SERVICE BULLETIN

Inspection and/or correction of turbocharger heat shield orientation for ROTAX® Engine Type 915 i A and 915 i B (Series)

MANDATORY

Fig. 1

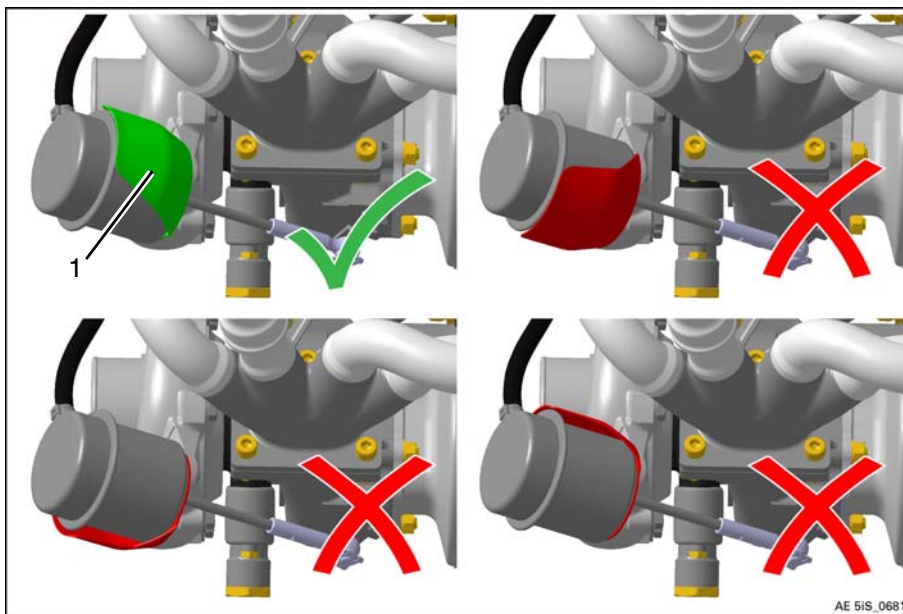
Step	Procedure
1	Inspect the wastegate regulator heat shield (1) for correct position. NOTE: The heat shield must be positioned to provide maximum shielding of radiant heat from the exhaust system. The heat shield must point towards the turbocharger exhaust turbine inlet. See Fig. 1 for correct alignment.
2	If the heat shield is correctly positioned, no further action is required.
3	If the heat shield is in wrong position, follow the instructions in section 3.2 for correction.

1 Correct position of wastegate actuator heat shield

Fig. 3

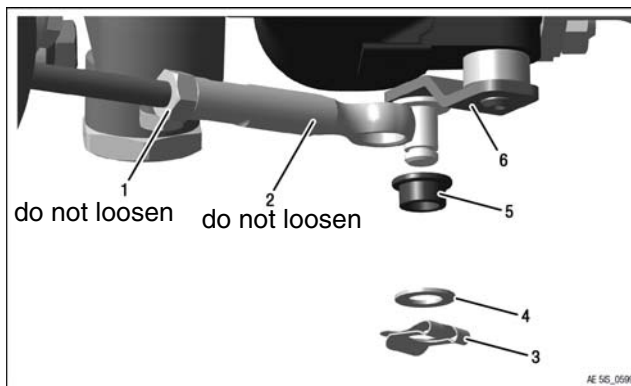
Do not loosen wastegate regulator rod end or locking nut.

Step	Procedure
1	Remove the locking clip, washer and rod end from the wastegate lever.
2	Remove bushing from the wastegate lever.

Fig. 4

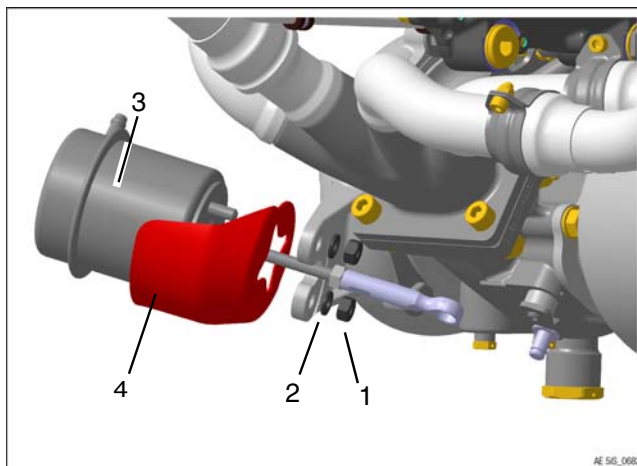
Step	Procedure
3	Remove two collar nuts with washers from the wastegate regulator.
4	Remove wastegate regulator assy. and heat shield.

Step	Procedure
5	Install the heat shield over the studs of the wastegate regulator in correct position. NOTE: The heat shield must point towards the turbocharger exhaust turbine inlet. See Fig. 1 for correct alignment.
6	Place wastegate regulator assy. and heat shield back into turbocharger housing.

Fig. 5

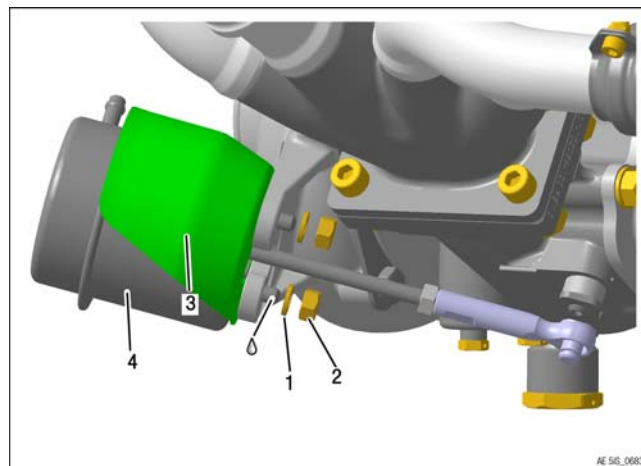
Step	Procedure
7	Apply LOCTITE 243 onto wastegate regulator assy. studs.
8	Install collar nuts and washers. Tightening torque 13 Nm (115 in.lb).
9	Apply LOCKING PAINT (or equivalent) to the top of both collar nuts/studs.

Fig. 6

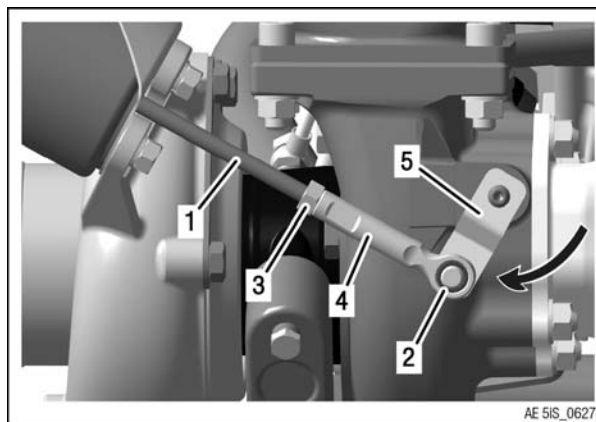
Step	Procedure
10	Lubricate the bushing with LOCTITE ANTI SEIZE 8151 (or equivalent).
11	Place the bushing onto the wastegate lever shaft with the bushing collar facing towards the wastegate lever.
12	Rotate wastegate lever until end stop (closed position) and hold in position.
13	Place the rod end over the bushing so that the wastegate is still in closed position.

Fig. 7

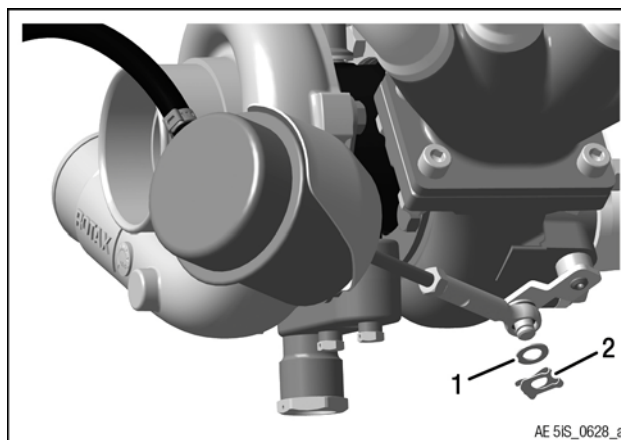
Step	Procedure
14	Place the washer over the wastegate shaft and hold in place.
15	Place the open end of the locking clip into the groove of the wastegate shaft and the beveled portion of the clip over the end of the shaft.
16	Push the locking clip into place until the beveled end retains the clip over the shaft.
